# HISTORIC AND DESIGN REVIEW COMMISSION

October 03, 2018

**HDRC CASE NO:** 2018-481  
**ADDRESS:** 1811 N PALMETTO  
**LEGAL DESCRIPTION:** NCB 993 BLK 3 LOT 20 & E 27.9 OF S 62.5 OF N 125 OF 7  
**ZONING:** R-6, HS  
**CITY COUNCIL DIST.:** 2  
**DISTRICT:** Government Hill Historic District  
**APPLICANT:** Diana Orosco  
**OWNER:** Diana Orosco  
**TYPE OF WORK:** Replacement of the existing, standing seam metal roof with an asphalt shingle roof  
**APPLICATION RECEIVED:** September 14, 2018  
**60-DAY REVIEW:** November 13, 2018  
**REQUEST:**

The applicant is requesting a Certificate of Appropriateness for approval to replace the existing, standing seam metal roof with an asphalt shingle roof.

1912 SANBORN MAP

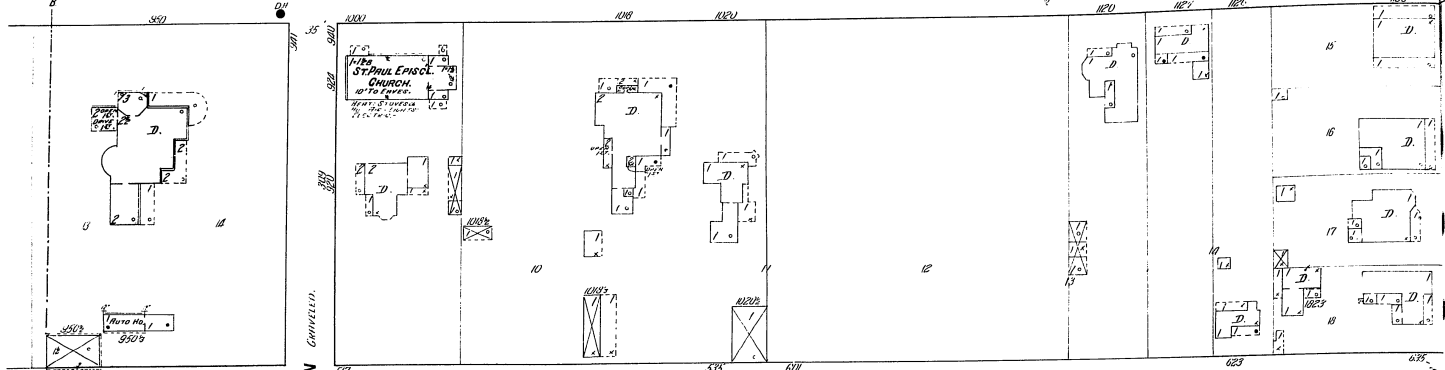
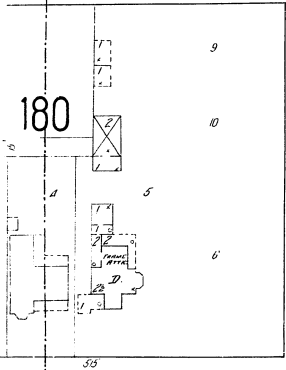
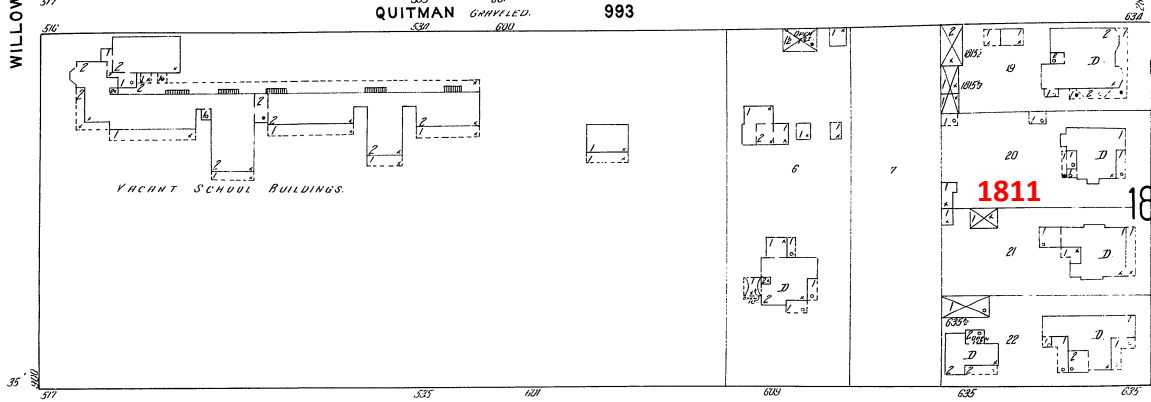
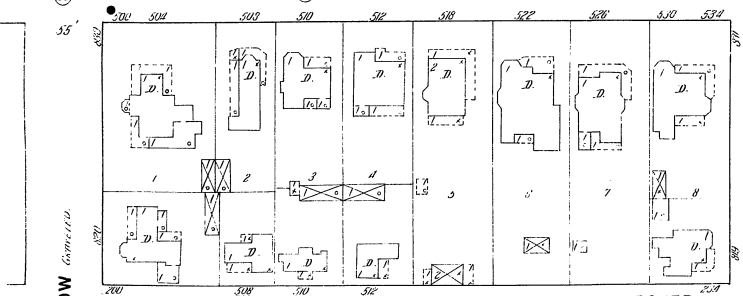
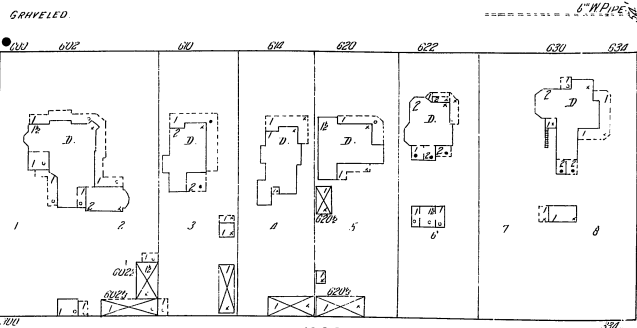
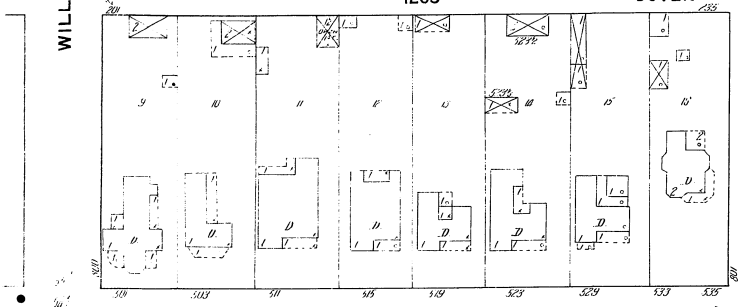
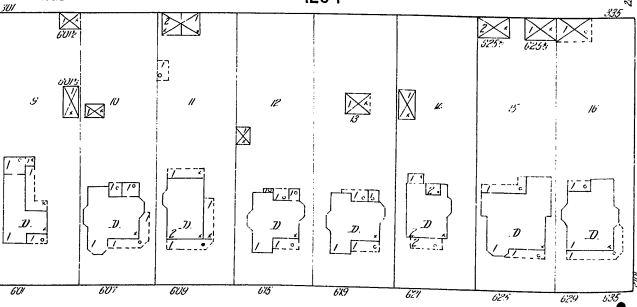
- a. The historic structure located at 1811 N Palmetto was constructed circa 1910 and is first found on the 1912 Sanborn Map. The structure was constructed in the Folk Victorian style and features a standing seam metal roof, two brick chimneys and turned columns.
- b. ROOF REPLACEMENT – The Guidelines for Exterior Maintenance and Alterations 3.B.vi. notes that metal roofs should be used on those where a metal roof is appropriate for the style of construction or on structures that historically featured a metal roof. The 1912 Sanborn Map notes a non-combustible roof, in this instance, metal. Staff finds that the proposed asphalt shingle roof is not consistent with the Guidelines and finds that a metal roof should be installed to be consistent with the Guidelines.

Staff does not recommend approval based on finding b. Staff recommends that a standing seam metal roof be installed to feature panels that are 18 to 21 inches in width, seams that are 1 to 2 inches in height, a crimped ridge seam and a standard galvalume finish.
